**TOWN OF MOUNTAIN VILLAGE  
REGULAR DESIGN REVIEW BOARD MEETING  
AGENDA**

**THURSDAY FEBRUARY 4, 2021 10:00 AM**

**TO:** Mountain Village Design Review Board  
**FROM:** John Miller, Senior Planner  
**FOR:** Design Review Board Public Hearing; February 4, 2021  
**DATE:** January 22, 2021 (continued from January 7, 2021)  
**RE:** Staff Memo – Initial Architecture and Site Review (IASR) Lot BC513E

SHEET NUMBER:  
**A202**

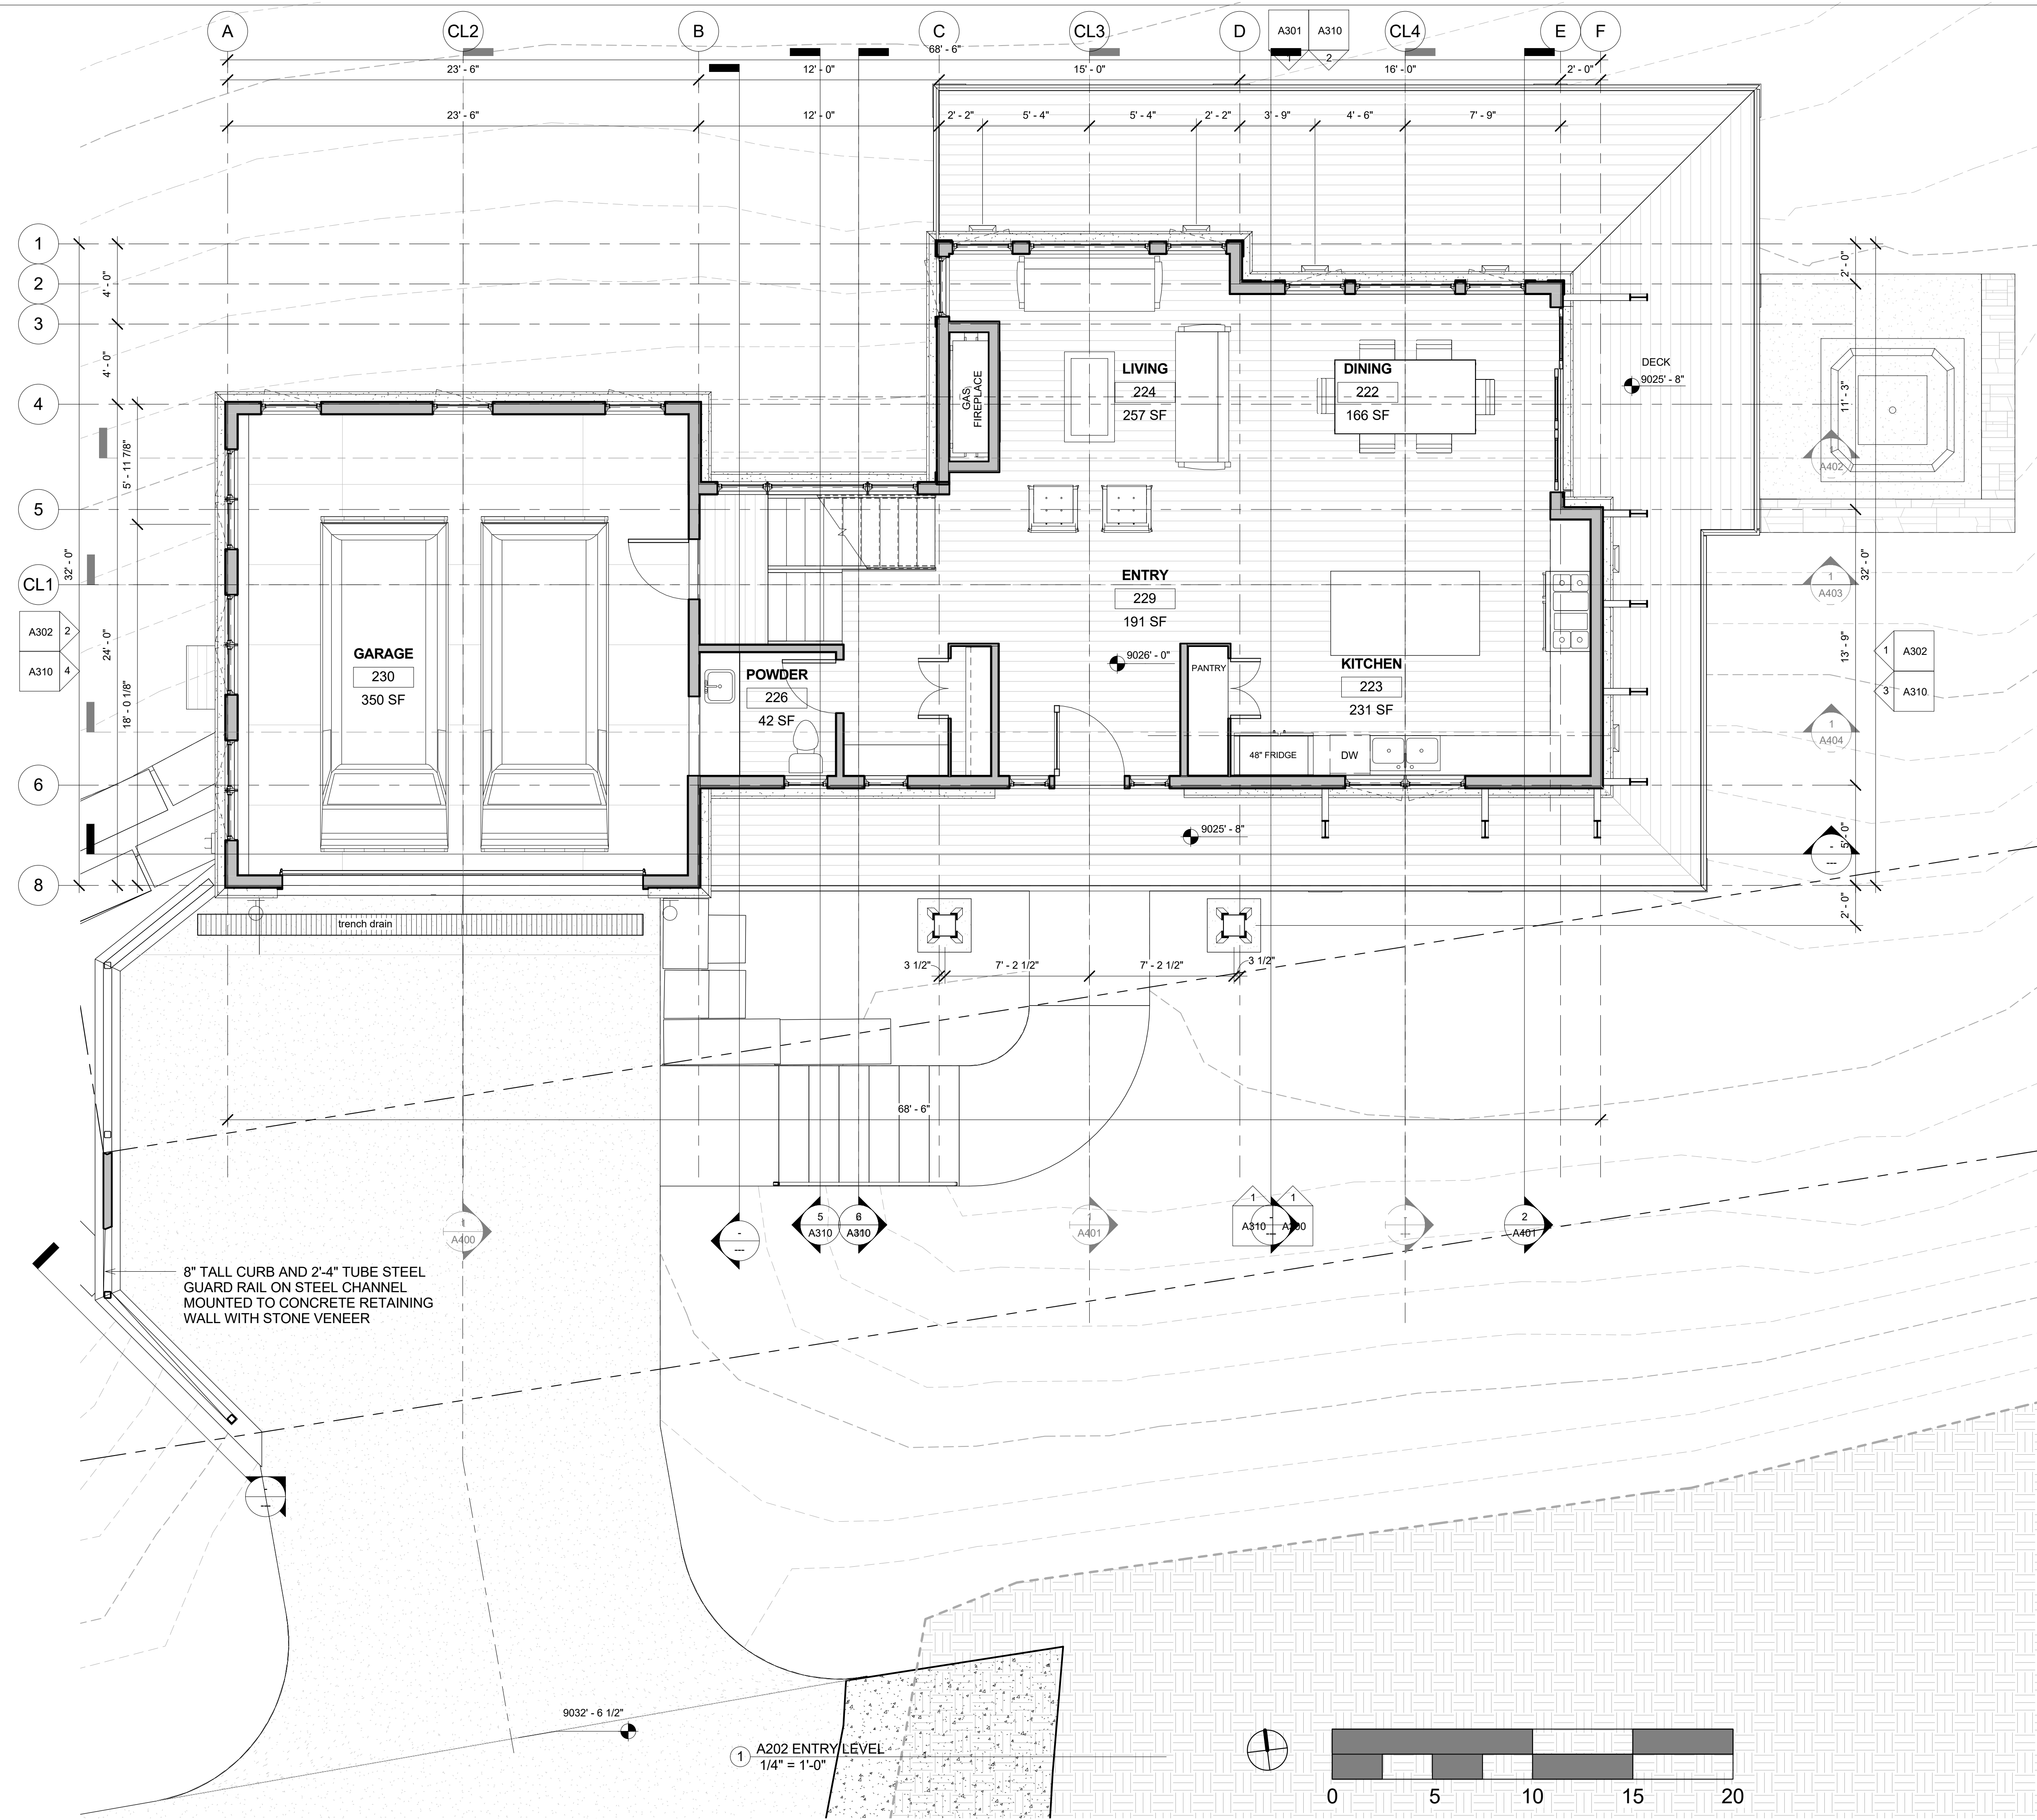
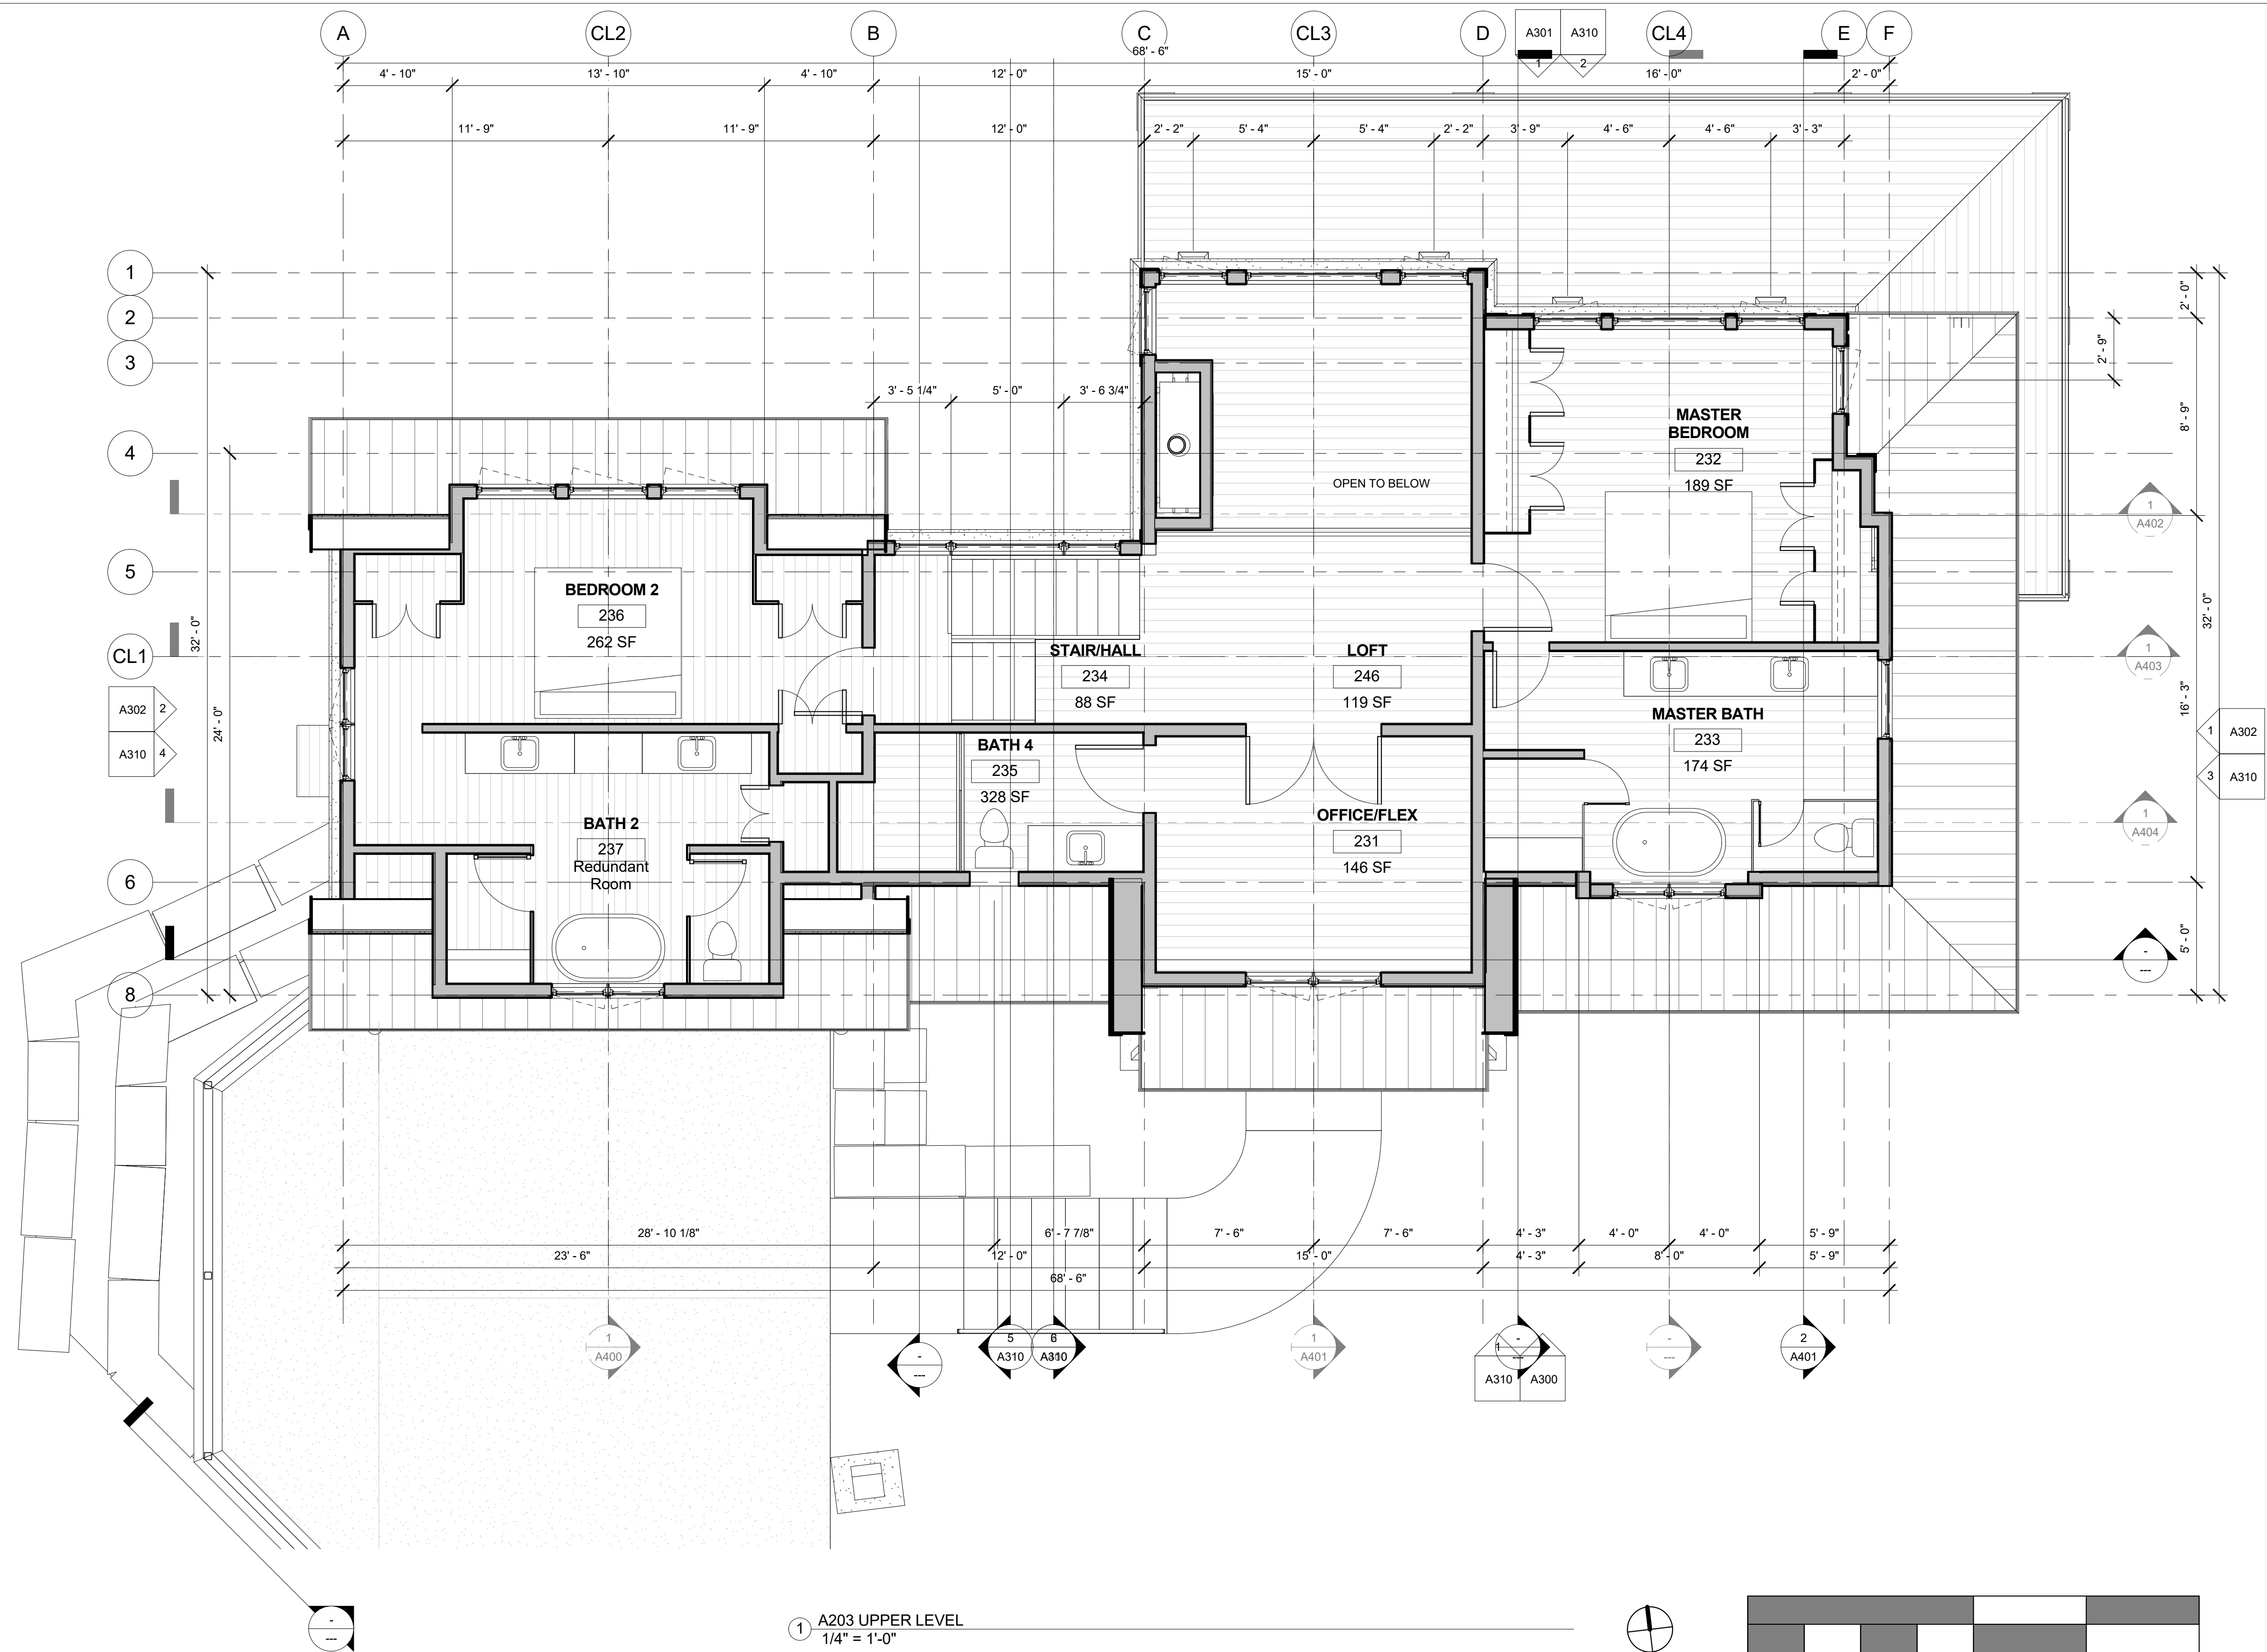
*Staff: The CDC requires all single-family developments to provide two interior and two exterior parking spaces. The applicant has shown a total of 2 interior spaces on Page A202 but has not provided for the exterior spaces within the plan set. Based on the Construction Mitigation Plan, it appears that there is room for 2 exterior parking spaces within the Southern GE but the DRB will need to determine if this is appropriate per the comments discussed above related to GE encroachments.*
